Airport Industrial Development Complex - Self Storage Facility

DESIGN CHANGES

VIEW FROM SOUTH EAST - PREVIOUSLY REVIEWED BY ARB ON 8-24-2026

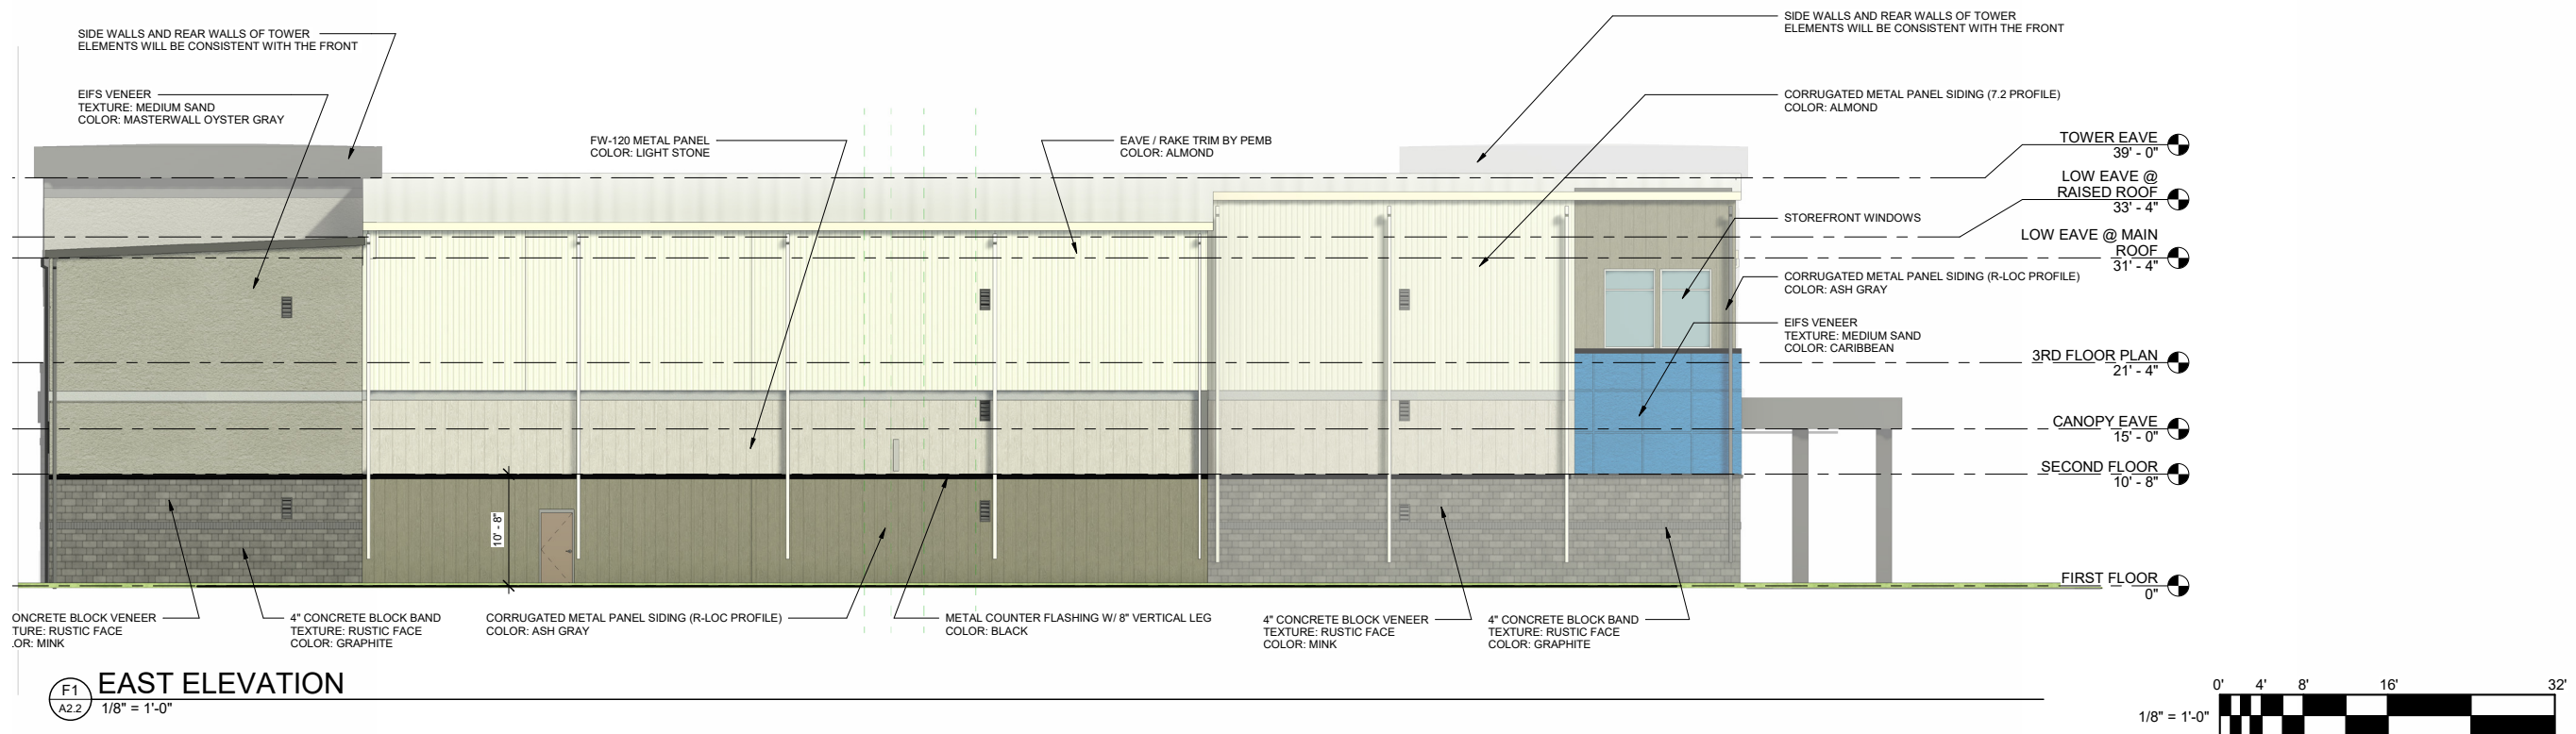
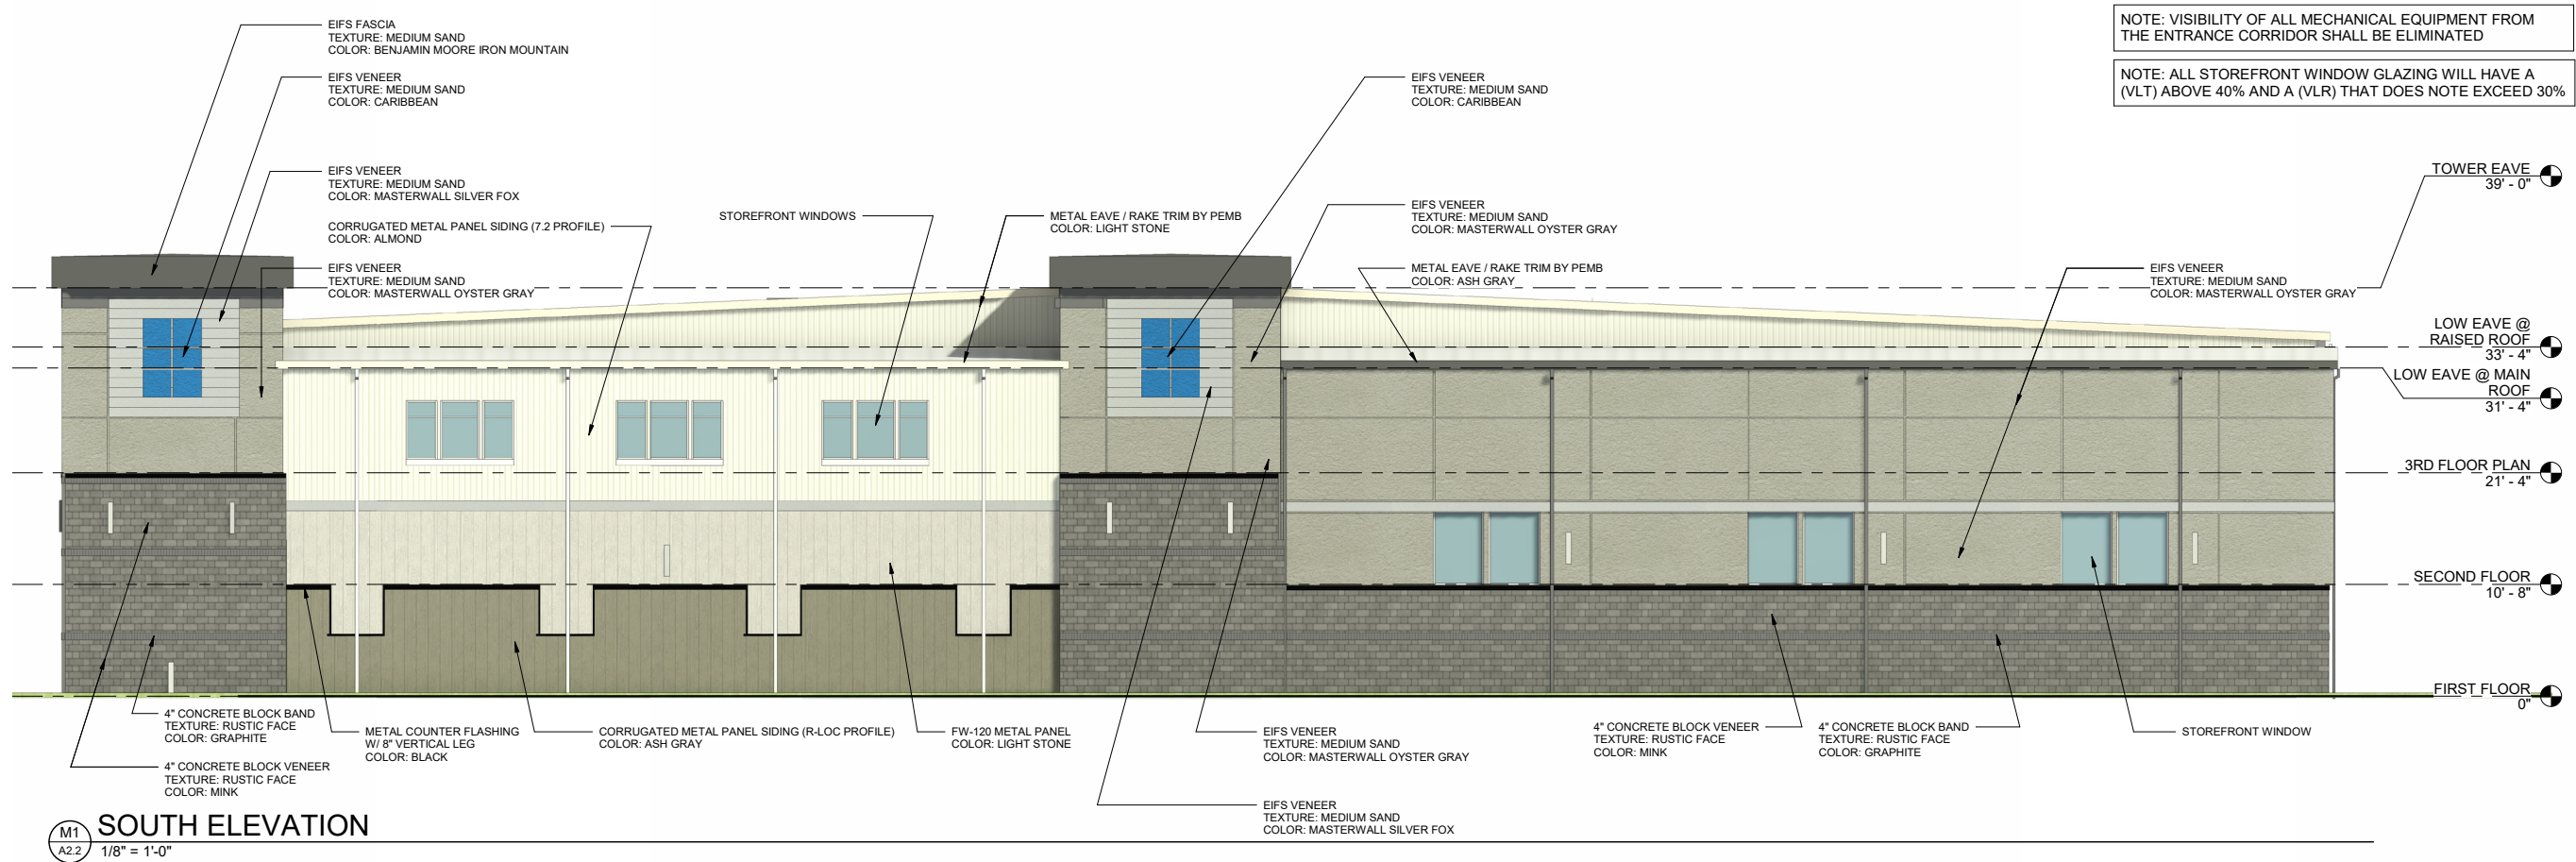
- 1. Roof configuration changed to eliminate the visible rake slope facing Airport Rd. at the east end of the facade in favor of low eave gutter and downspouts, which are aligned with the same condition at along the western end of the facade
- 2. Elimination of masonry window surround detail at the eastern side of the Aiport Rd. facade.
